**Preliminary Alternative Technical Concepts (ATC) Submittal**  
**BEL-70-9.35 Interchange Improvement**  
**Design-Build**  
**Belmont County, Ohio**  
**PID 120547**

## Contents

Red - Proposed on Conceptual

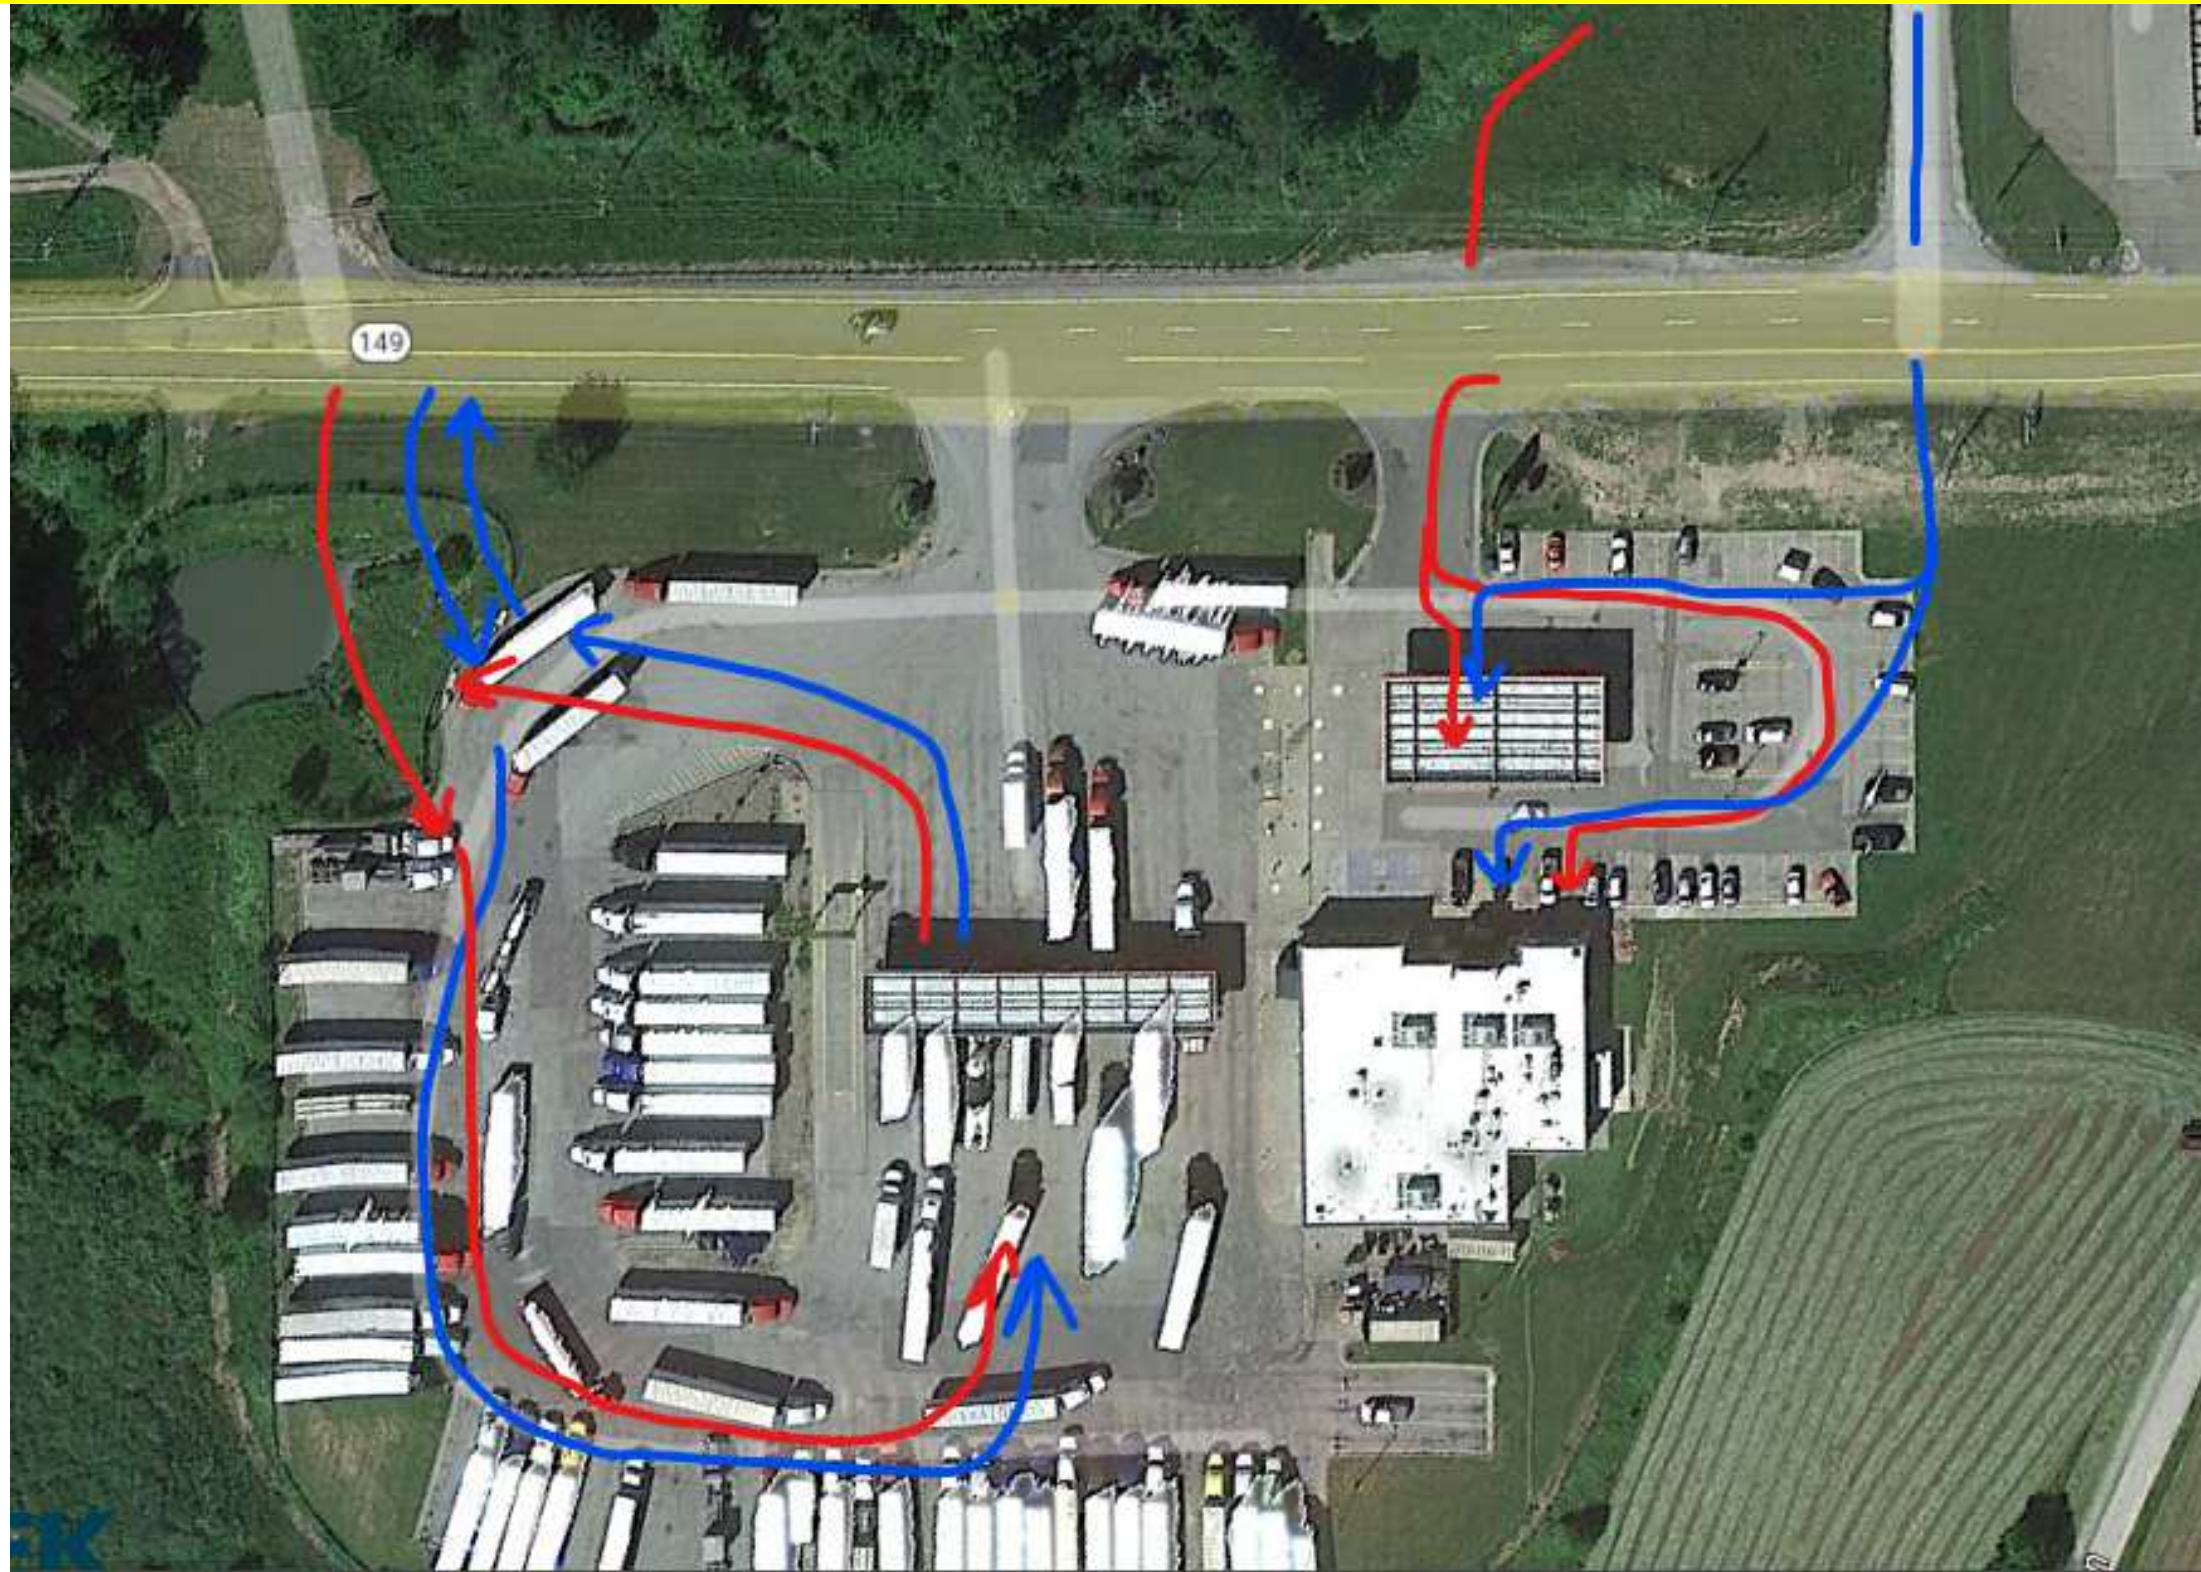
1. **Description:** This ATC proposes a modification to the driveway configuration requirements as outlined on Page 39 of 63 in the BEL-70-9.35, PID 120547 SCOPE OF SERVICES (Addendum 1). The original specification mandates that the DBT follow the geometrics depicted in the Conceptual Plans regarding proposed driveway configurations and existing driveway removals.

The DBT proposes to modify this requirement to design the driveways with input from the driveway owners. This change allows for the incorporation of feedback and specific requirements from the local entities regarding truck traffic control, ensuring that the final driveway configurations meet the needs of these key stakeholders while maintaining compliance with the overall project design. See Exhibit D for additional details.

2. **Deviation:** Page 39 of 63 in the BEL-70-9.35, PID 120547 SCOPE OF SERVICES (Addendum 1) states: *"The DBT shall follow the geometrics depicted within the Conceptual Plans in regard to proposed driveway configurations and existing driveway removals."*

The DBT proposes to modify the above language to: *"The DBT shall design the driveways to geometrics acceptable to the truck stop entities, specifically DR-1 shown on 120547\_Appendix Conceptual Plans, which will have an intersection point between Sta. 114+50 - 116+50."*
